MEMORANDUM FOR:

Neil M. Coleman  
Hydrology Section  
Geotechnical Branch

STATUS REPORT ON THE COLD CREEK HYDROLOGIC ANOMALY

Figure 1.  
Well Location Map

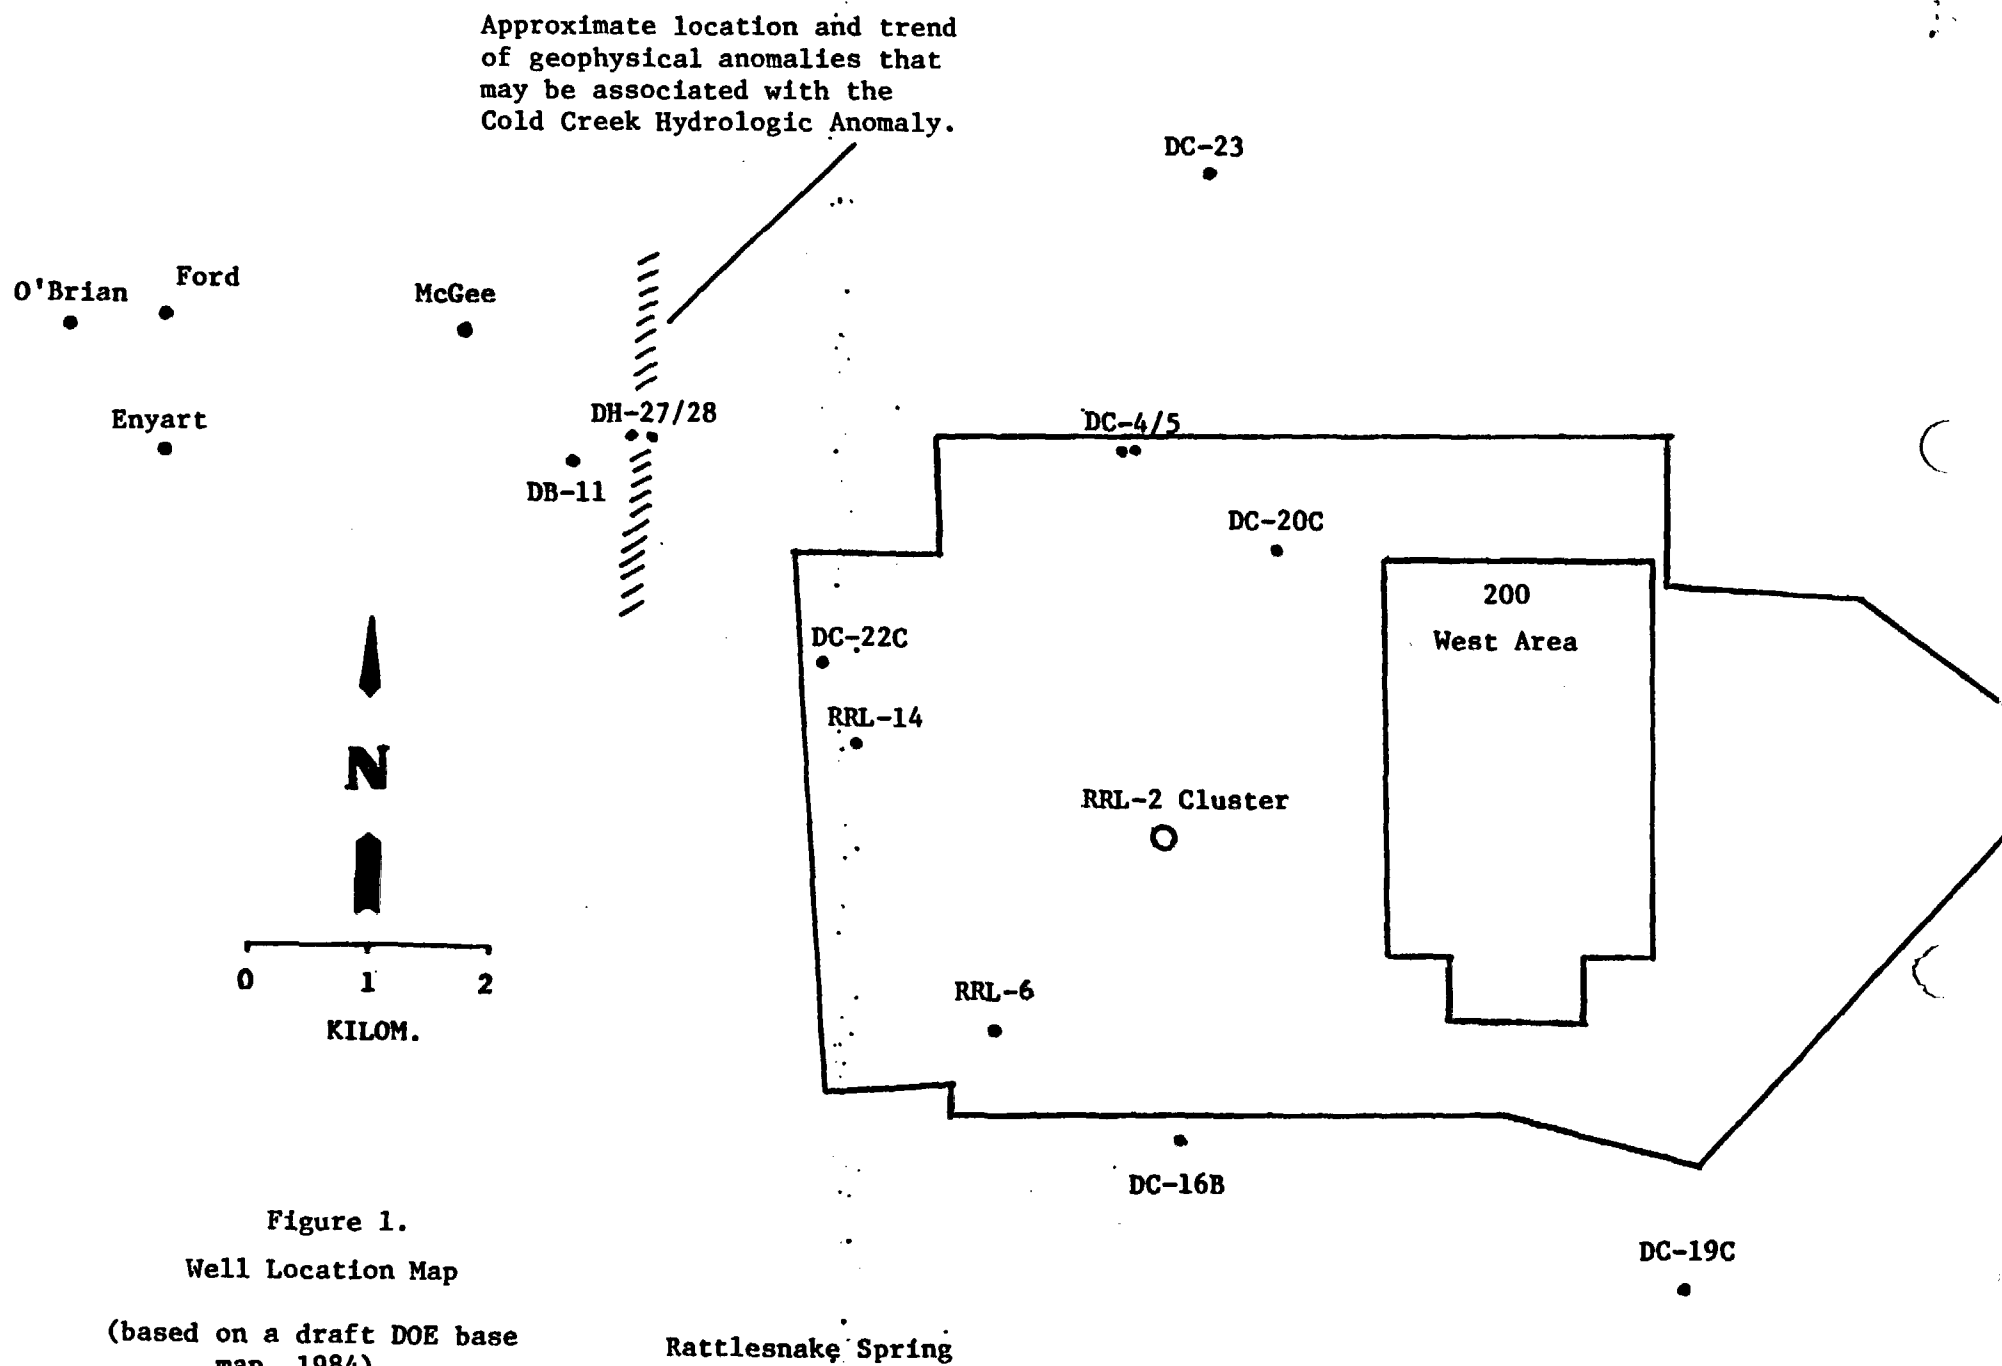
The hydrologic anomaly consists of a zone of contrasting hydraulic head differences located less than 2 km northwest of the Reference Repository Location (RRL) (see Figure 1). The anomaly and associated geophysical signatures have been variously referred to as the Cold Creek Barrier, the Nancy Linear, the Cold Creek Impediment, the N 96 to N 84 "Linear", and, more recently, as the Cold Creek Syncline Hydrologic Barrier (CCSHB). In this memorandum the term "Hydrologic Anomaly" is used because the nature and physical characteristics of the geologic structure that causes the anomaly have not been characterized. This anomaly is one of a number of subsurface phenomena that have been targeted by the Basalt Waste Isolation Project (BWIP) for hydrologic characterization.

In the BWIP Site Characterization Report (USDOE, 1982), the following comments were presented on page 5.1-61 regarding a possible hydrologic barrier: "Hydraulic heads within the Mabton interbed decrease nearly 80 meters between borehole DB-11 (head of 204.2 meters above mean sea level), which lies west of the Cold Creek structural barrier, compared to boreholes near the reference repository location. In comparison, the hydraulic head of the Priest Rapids Member of the Wanapum Basalt at DB-11 is 280 meters above mean sea level. This is 76 meters greater than that in the overlying Mabton interbed at that same borehole and some 160 meters larger than the Priest Rapids heads east of the structural barrier. Therefore, the confining nature of this barrier might increase with depth. Future drilling and testing will determine whether or not these head differences across the barrier continue into the lower Wanapum and Grande Ronde Basalts." Well locations are shown in Figure 1 (attached).
